3.3 Comment Letters Received for the Recirculated Portions of the Draft Environmental Impact Report

Letter R.A: Kelilah D. Federman, Adams Broadwell Joseph & Cardozo, for California Unions for Reliable Energy (January 12, 2022)

Re: Comments on Recirculated Draft Environmental Impact Report for Estrella Substation and Paso Robles Area Reinforcement Project

Figure 3: Aldehydes Emitted from a T63 Engine Helicopter

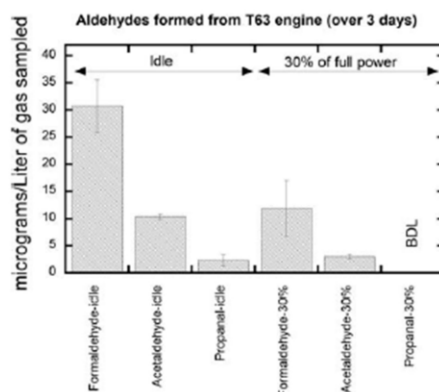
Another study found that helicopter engine exhaust contains high concentrations of aldehydes—for example, formaldehyde, acetaldehyde and hydrocarbons, including benzene, a potent carcinogen, and numerous acutely and chronically toxic hydrocarbons, including toluene, ethylbenzene, xylenes, and naphthalene. The highest concentrations occur during idling.⁴³ Figures 3 and 4.

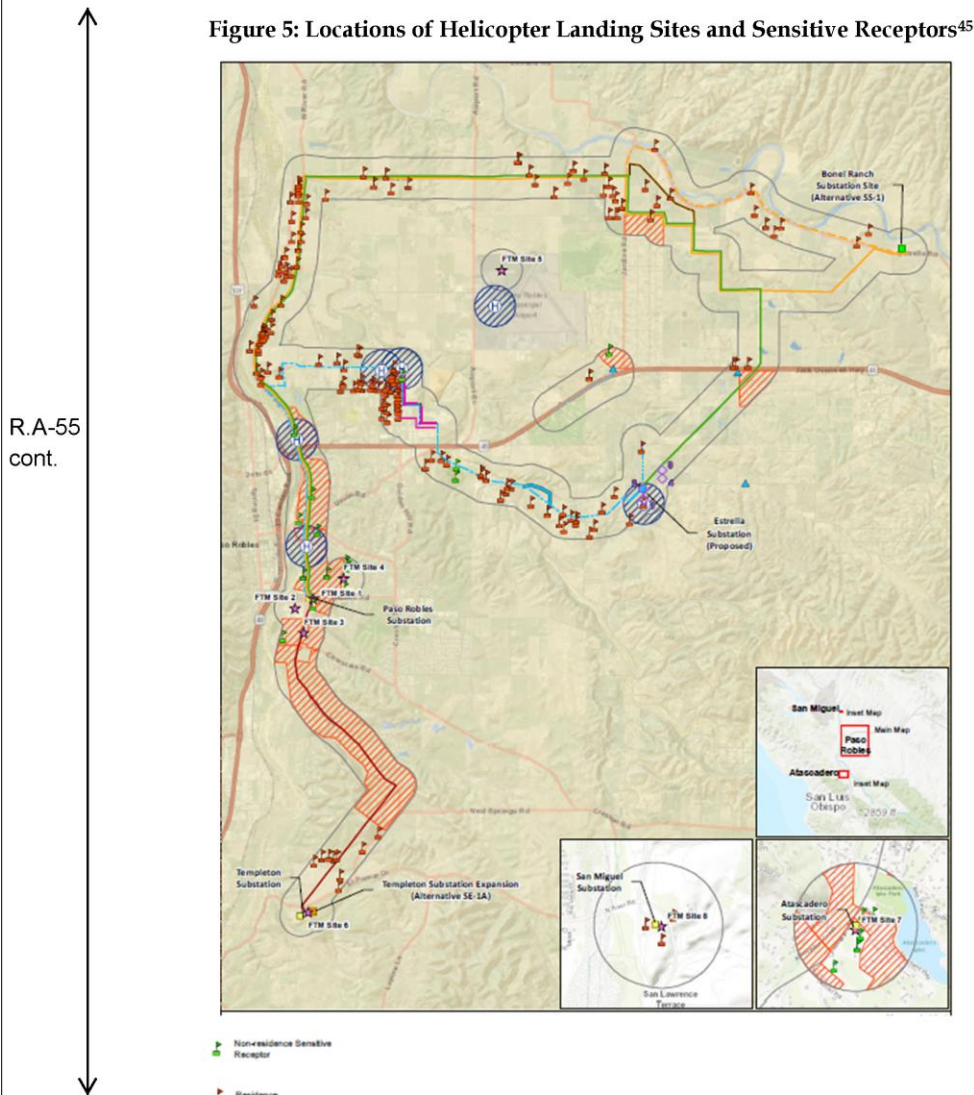
Helicopters used during construction and operation pose potentially significant health impacts to construction workers, as well as nearby sensitive receptors because several of the landing zones are near residences and other sensitive receptors. Figure 5.

The DEIR asserts that helicopter operation would be planned to avoid sensitive receptors and limited to 7:00 AM to 5:30 PM, Monday through Friday and Saturdays when needed. However, Figure 5 shows that helicopter landing sites are adjacent to residences and nonresident sensitive receptors. Thus, clearly, sensitive receptors will not be avoided.

- Landing zones for helicopters and areas where bulldozers, graders, or skid steer operate require continuous wetting. This is particularly critical where landing zones are adjacent to residential areas. Figure 5. (Omitted in the RDEIR.)
